A	H-2255	1/21/76	W. R. Kline	W. R. Kline	W. R. Kline	FOR PARALLEL AND INSTALLATION		H	H-2255	11-12-80	W. R. Kline	W. R. Kline	W. R. Kline	SEE NOTE REV. H		W. R. Kline	1/4"	4130	NSV LEAKAGE CONTROL SYSTEM (LC)

B	H-2255	11/23/76	W. R. Kline	W. R. Kline	W. R. Kline	FOR PARALLEL AND INSTALLATION													NSV, ZIMMER NUCLEAR POWER STATION UNIT-1

NSIV LEAKAGE CONTROL SYSTEM (LC)
 W. R. Kline Nuclear Power Station Unit-1
 THE CINCINNATI GAS & ELECTRIC COMPANY
 COLUMBUS & SOUTHERN OHIO ELECTRIC COMPANY
 THE DAYTON POWER AND LIGHT COMPANY

SARGENT & LUNDY
 ENGINEERS
 CHICAGO
 DRAWING NO. 1154
 SHEET 2 OF 2

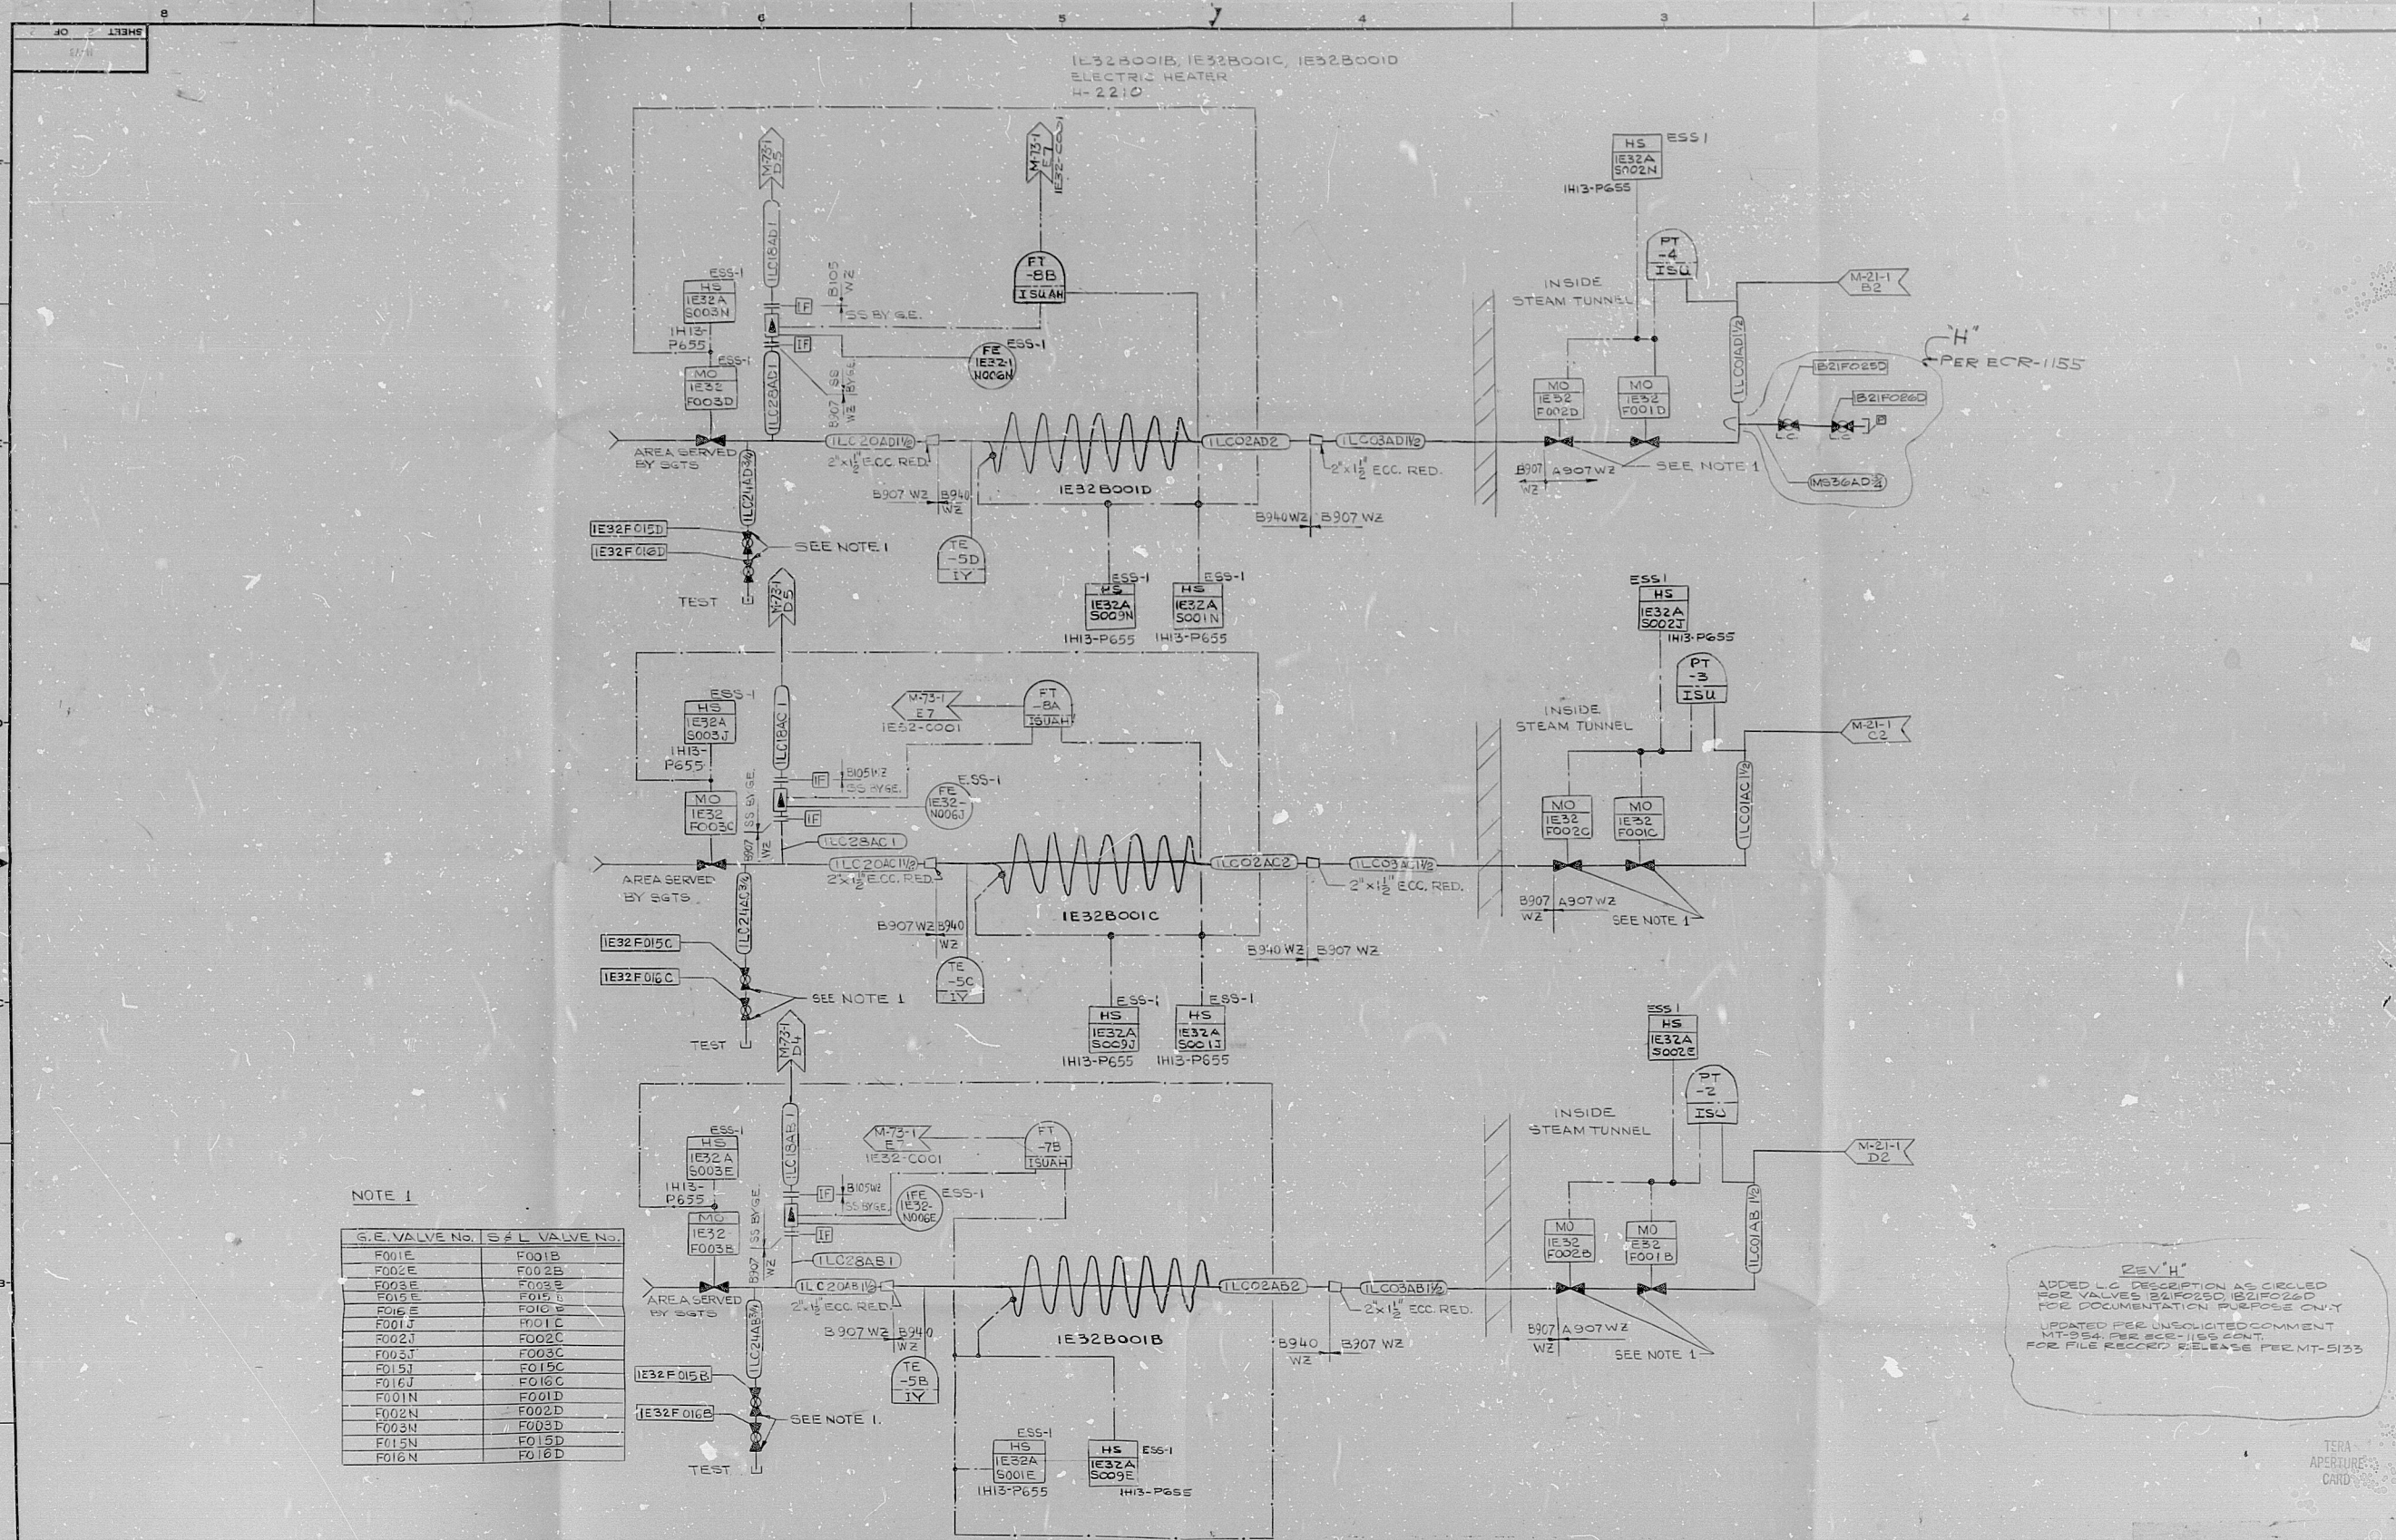
REV. H
 ADDED LC DESCRIPTION AS CIRCLED FOR VALVES IE32F002B, IE32F002C, IE32F002D FOR DOCUMENTATION PURPOSE ONLY
 UPDATED PER UNCLASSIFIED COMMENT MT-354 PER SEC-1155 CONT. FOR FILE RECORD RELEASE PER MT-5133
